2018 Annual Inspection Report

for Compliance with the Coal
Combustion Residuals Rule
(40 CFR Part 257)

Comanche Station

January 18, 2019

Appendix A – Landfill Site Map

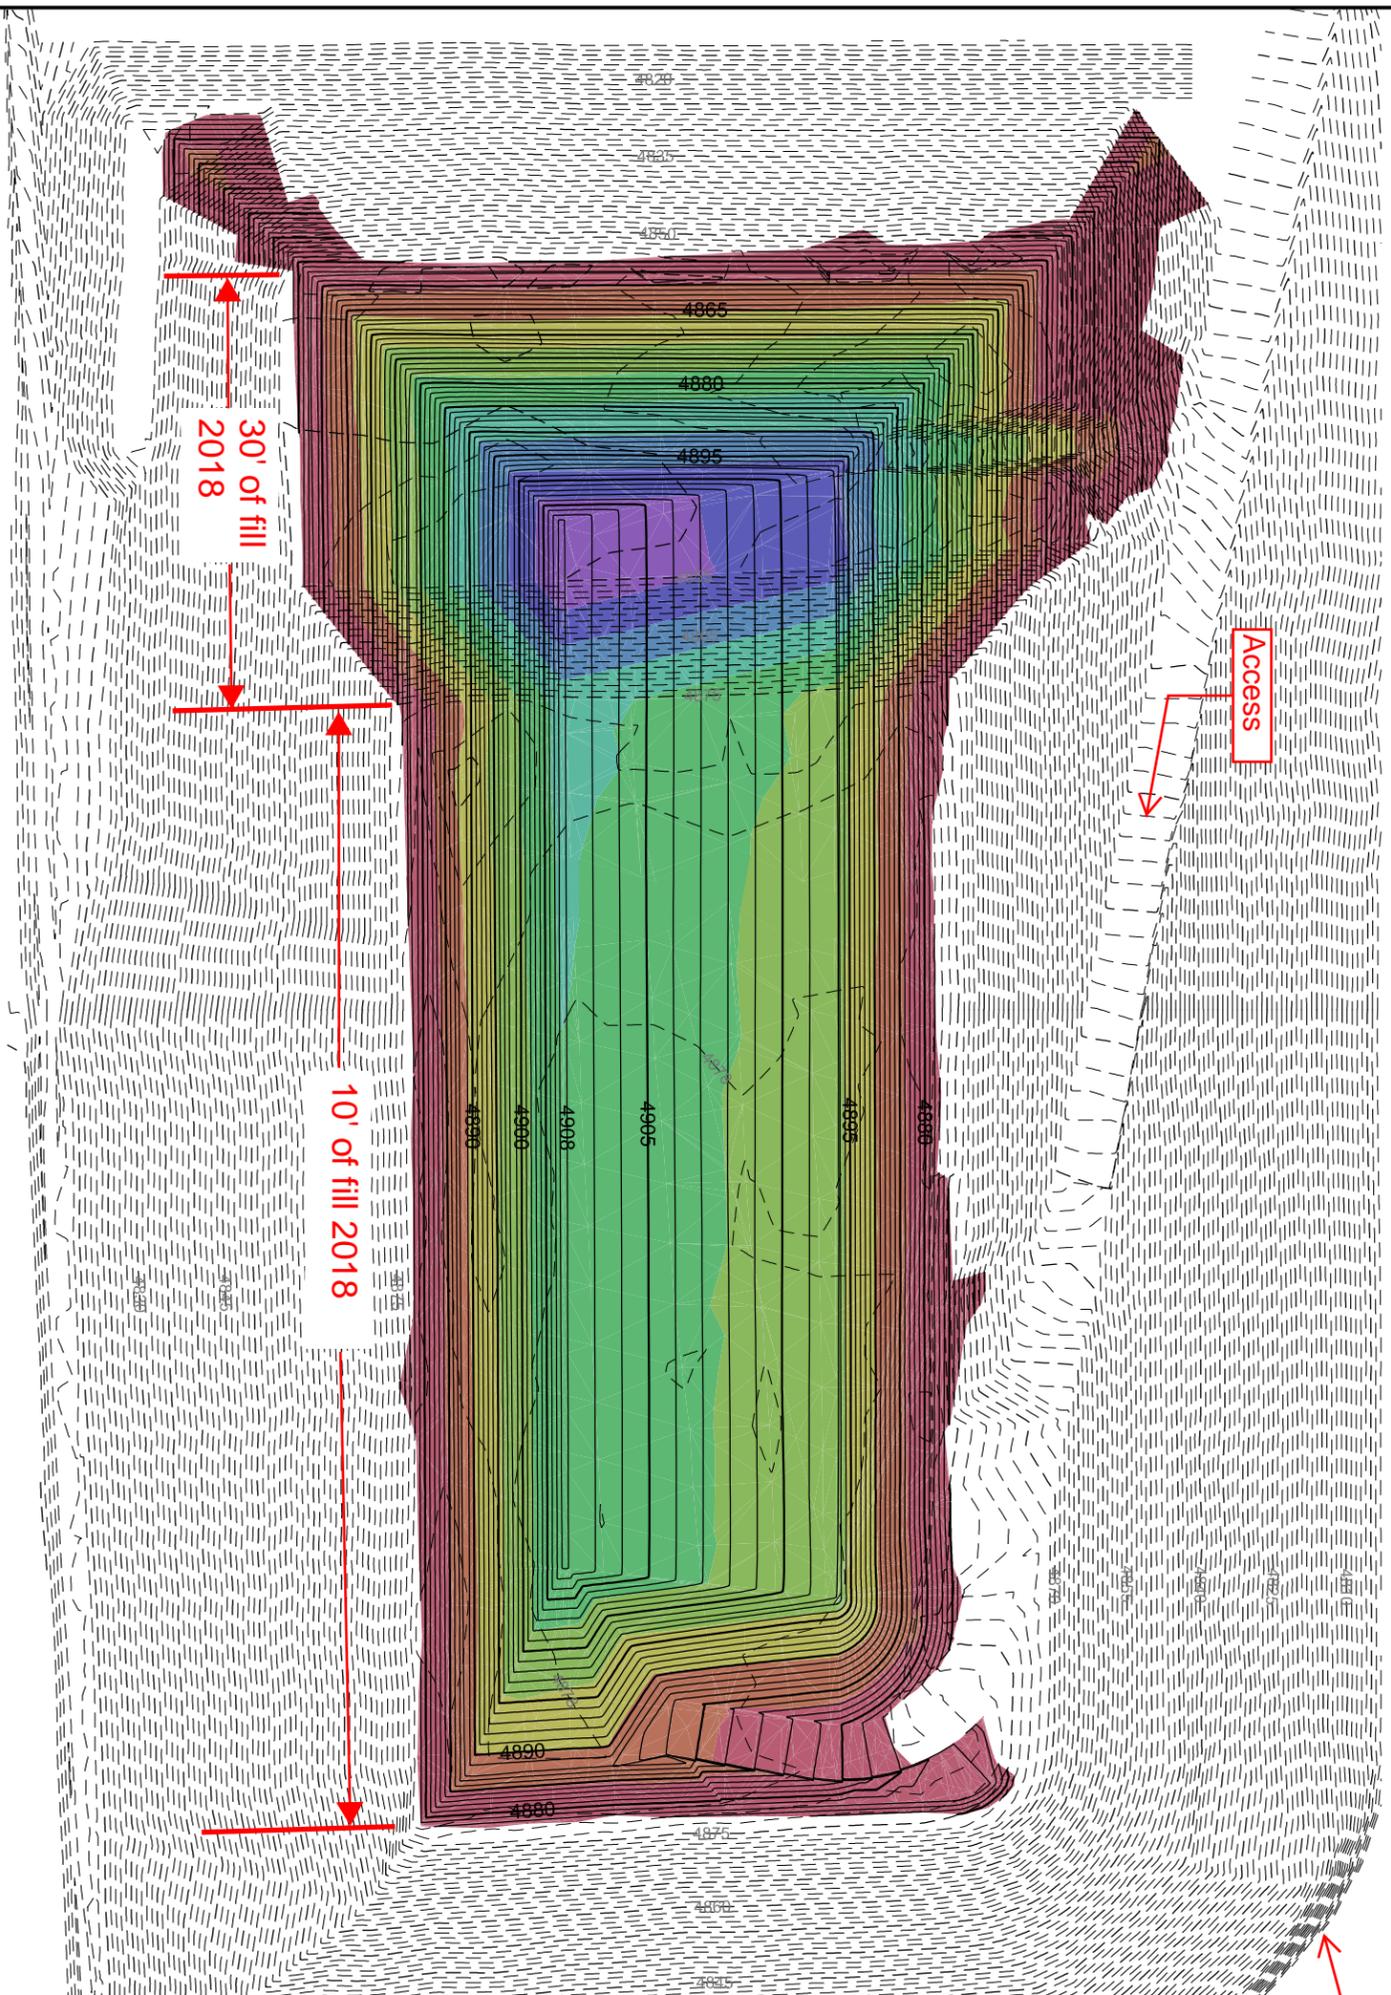
SE embankment corner with toe cut modified in 2018. Slope reworked to match surrounding grades. Topography shown does not reflect new grades.
